PROJECT NUMBER: SP2022-063  
PROJECT NAME: Site Plan for PK Floors  
SITE ADDRESS/LOCATIONS: 125 E RALPH HALL PKWY

CASE CAPTION: Discuss and consider a request by Steven Reyes on behalf of Patrick Kelley for the approval of a Site Plan for an Office/Showroom Facility on a 0.291-acre parcel of land identified as Tract 12-2 of the E. P. G. Chisum Survey, Abstract No. 64, City of Rockwall, Rockwall County, Texas, zoned Commercial (C) District, addressed as 125 E. Ralph Hall Parkway, and take any action necessary.

**TO:** Planning and Zoning Commission  
**DATE:** January 10, 2023  
**APPLICANT:** Steven Reyes  
**CASE NUMBER:** SP2022-063; *Site Plan for PK Floors*

ELEVATIONS

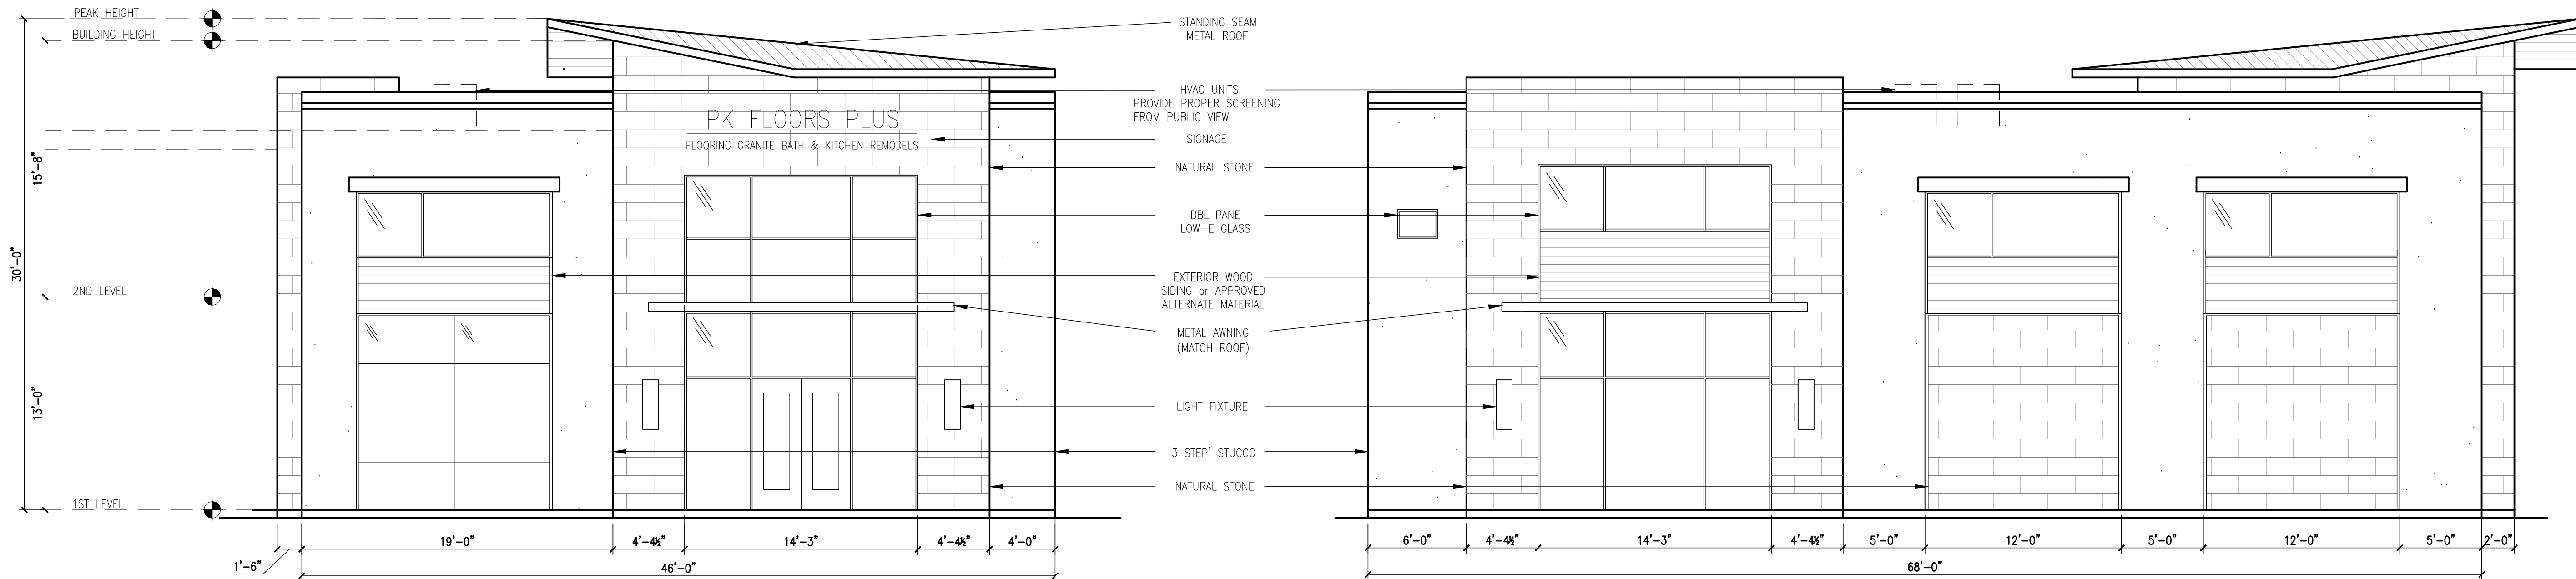
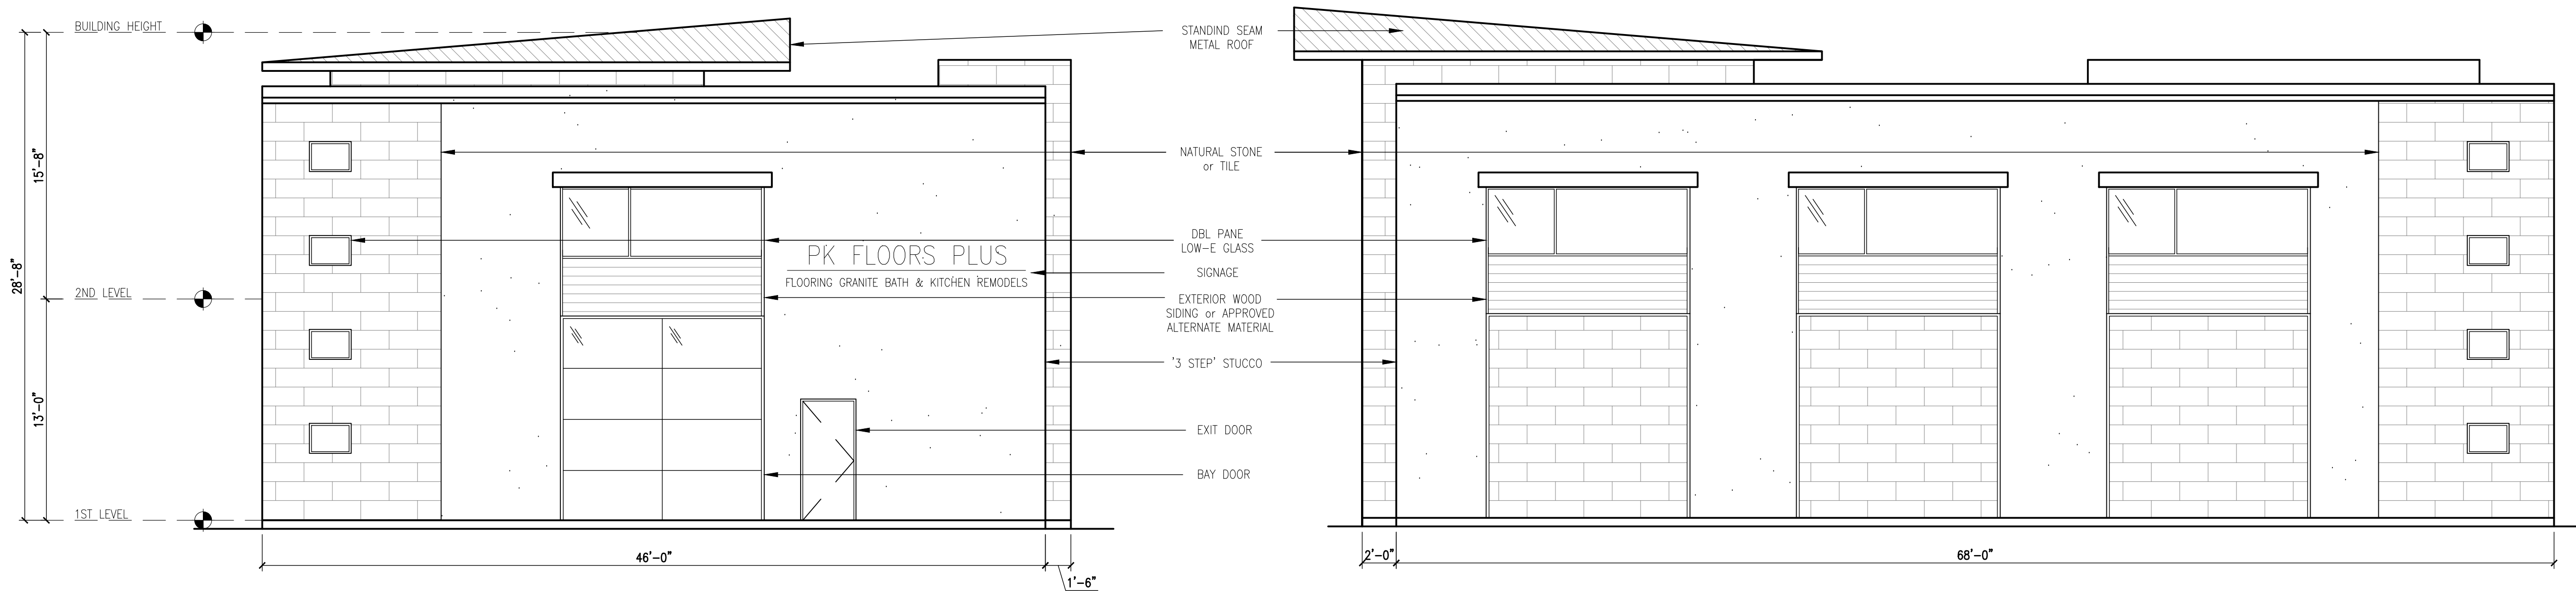
4. The proposed building does not meet the primary and secondary façade articulation requirements. For the primary façade articulation, the wall projection and projection height articulation requirements are not met. For the secondary façade articulation, the projection height requirement is not met. Please review Figure 7, within the General Commercial District Standards of the Unified Development Code (UDC). Exception to this may be requested by two (2) compensatory measure must be provided. (Subsection 04.01. A, 1, of Article 05)

I.9 Staff has identified the following exceptions associated with the proposed request: [1] roof pitch, [2] primary articulation, and [3] secondary articulation. Should you decide to request these items as exceptions, please provide a letter that lists the exceptions, why they are being requested, and the subsequent compensatory measures. For each exception requested the UDC requires two (2) compensatory measures (Subsection 09.01, of Article 11). Examples of compensatory measures include the increased use of masonry material or stone, increased articulation, increased architectural elements, more pedestrian amenity, larger landscape planting sizes, etc.

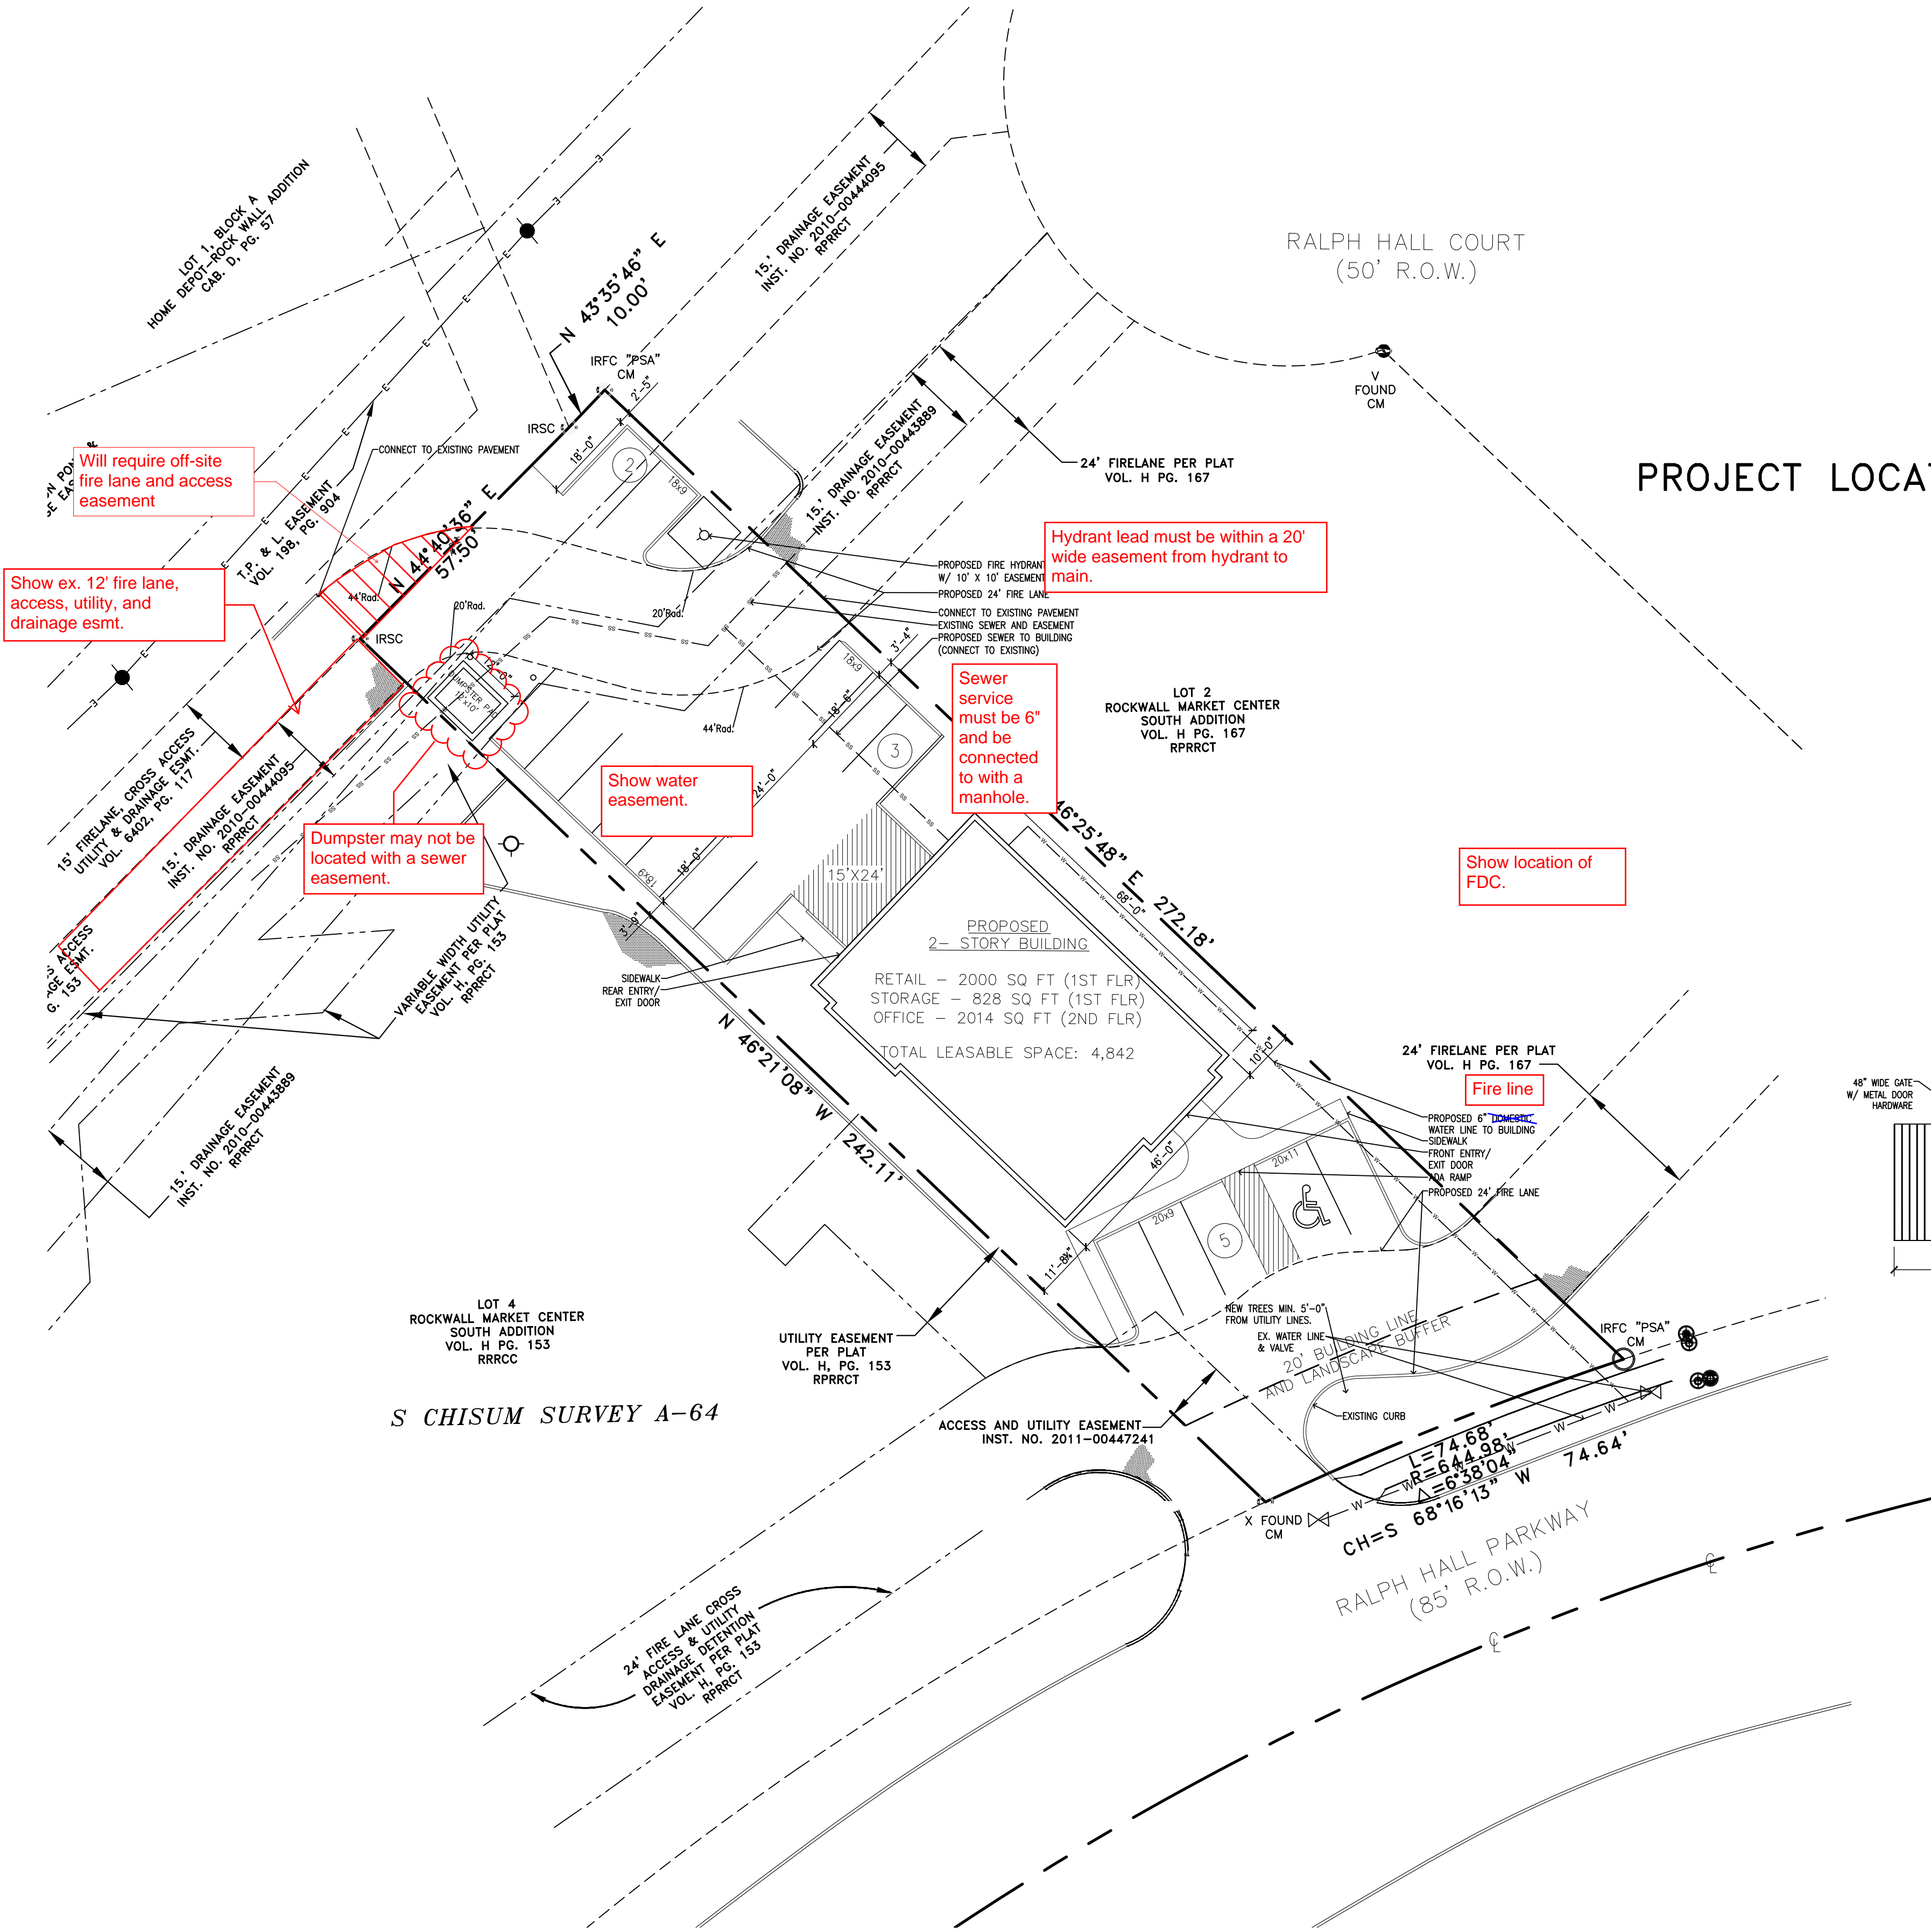
DEPARTMENT	REVIEWER	DATE OF REVIEW	STATUS OF PROJECT
ENGINEERING	Sarah Johnston	12/16/2022	Needs Review
12/16/2022: - Will require off-site fire lane and access easement.			
- Show ex. 12' fire lane, access, utility, and drainage esmt.			
- Dumpster may not be located with a sewer easement.			
- Show water easement.			
- Sewer service must be 6" and be connected to with a manhole.			
- Hydrant lead must be within a 20' wide easement from hydrant to main.			
- Show location of FDC.

- Show proposed utility lines (Water, Sewer, etc.)
- Any water lines must be a minimum of 8", looped, and must be in a 20' wide easement. (Meet City of Rockwall Standards of Design and Construction)
- Need to show existing water lines and fire hydrants

- Detention is required. Need to show approximate location on Site Plan
- Manning's C-value is per zoning type.
- Dumpster areas to drain to oil/water separator and then to the storm lines.

- General Items:**
- Must meet City Standards of Design and Construction
  - 4% Engineering Inspection Fees
  - Impact Fees for expansion
  - Minimum easement width is 20' for new easements. No structures allowed in easements.
  - Retaining walls 3' and over must be engineered.
  - All retaining walls must be rock or stone face. No smooth concrete walls.
  - Must plat the property.
  - No structures within easements.

- Roadway Paving Items:**
- Fire lane to be in a platted easement.

- Water and Wastewater Items:**
- Show proposed utility lines (Water, Sewer, etc.)
  - Any water lines must be a minimum of 8", looped, and must be in a 20' wide easement. (Meet City of Rockwall Standards of Design and Construction)
  - Need to show existing water lines and fire hydrants

- Drainage Items:**
- Detention is required. Need to show approximate location on Site Plan
  - Manning's C-value is per zoning type.
  - Dumpster areas to drain to oil/water separator and then to the storm lines.

SOUTH ELEVATION (FACING RALPH HALL PKWY)

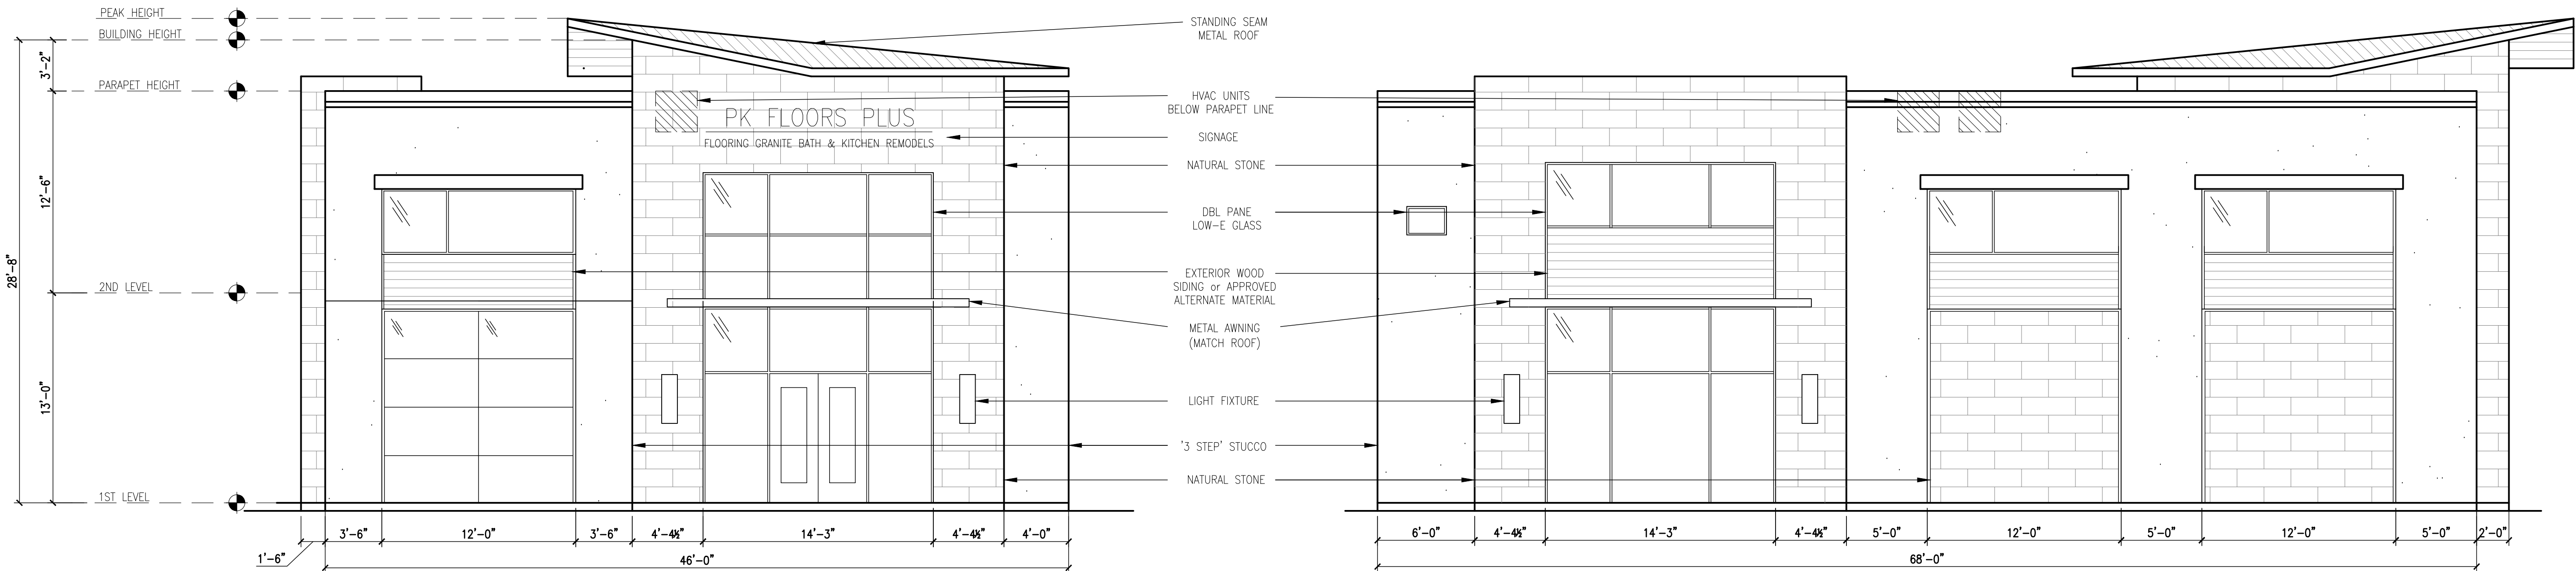
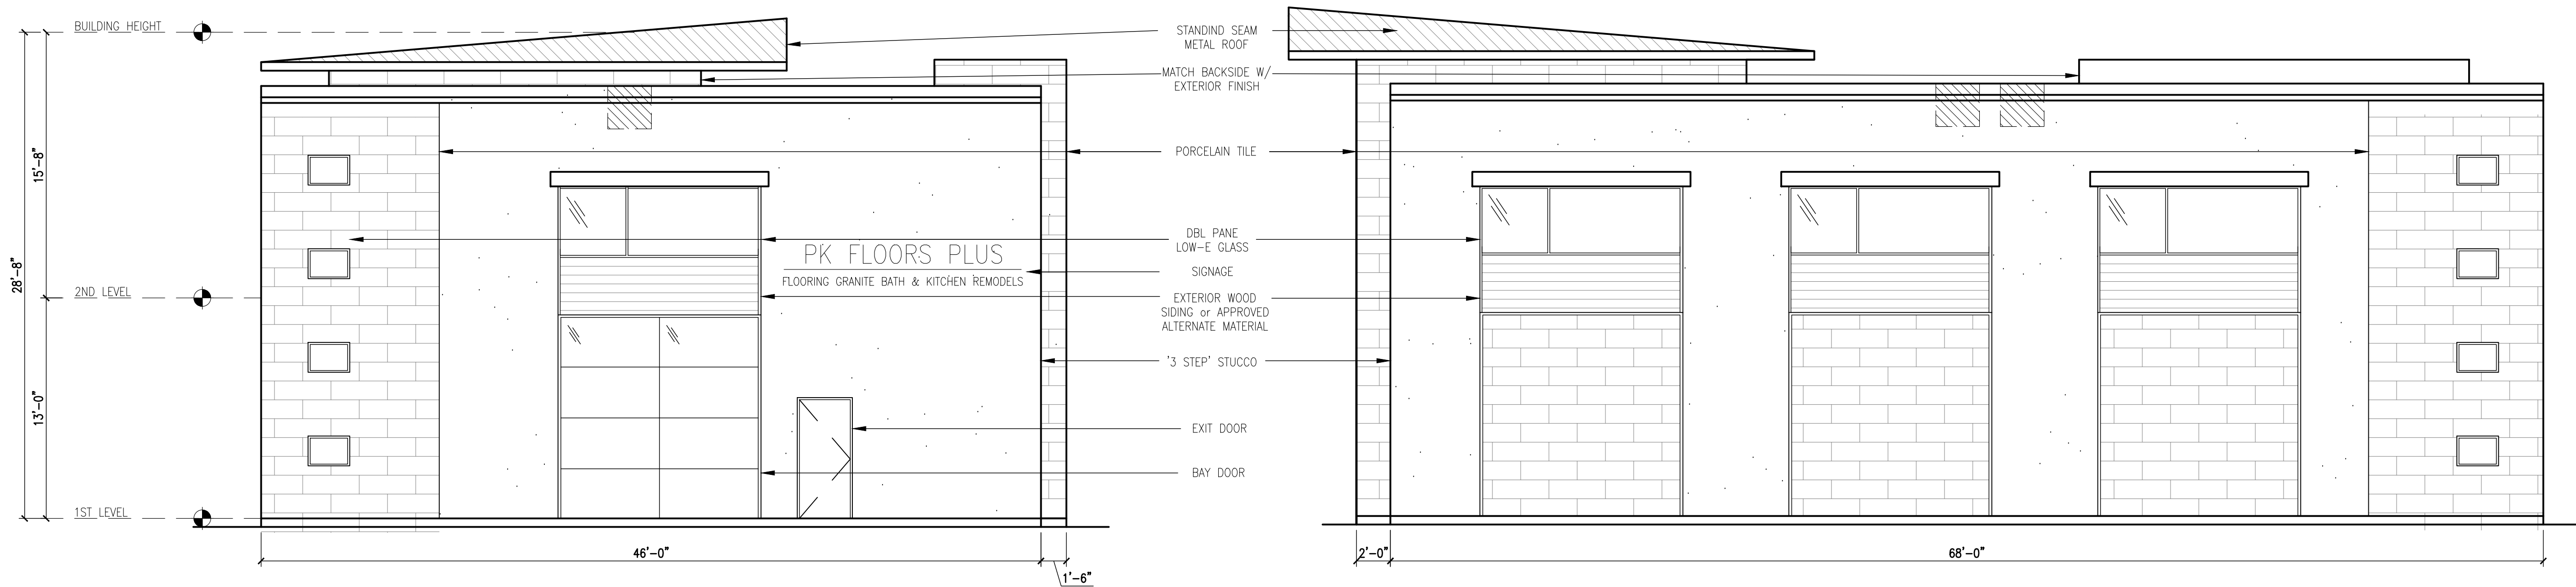
a pitched (minimum of a 6:12 roof pitch), parapet, or mansard roof system as long as the roof system is enclosed on all sides.” In this case, the applicant is requesting a roof pitch that is less than a 6:12 pitch. *This will require approval of an exception from the Planning and Zoning Commission.*

- (b) Primary and Secondary Articulation. According to Figure 7, *Commercial Building Articulation Standards*, of Subsection 04.01(C)(1 & 2), of Article 05, *District Development Standards*, of the Unified Development Code (UDC), the applicant fails to meet three (3) of the articulation requirements. [1] primary wall projections should be 25% of the wall height, [2] primary projection heights shall be 25% of the wall height, and [3] secondary projection heights shall be 15% of the wall height. *These will require approval of an exception from the Planning and Zoning Commission.*

On behalf of Mr. Kelley and PK FLOOR , Architectonics Texas would like to make to following request for approval concerning (1) the roof pitch exceeding the allowed limit of 6:12 slope (2) primary articulation and (3) secondary articulation. In our request, we propose to enhance or exceed with compensatory measures as identified on Landscape Plan L1.0.

The compensatory measures are to (1) increase the caliper size from 4" min. to 5" for all new canopy (2) increase the caliper size from 4" min. to 5" for all new accent trees (3) add 2 accent trees.
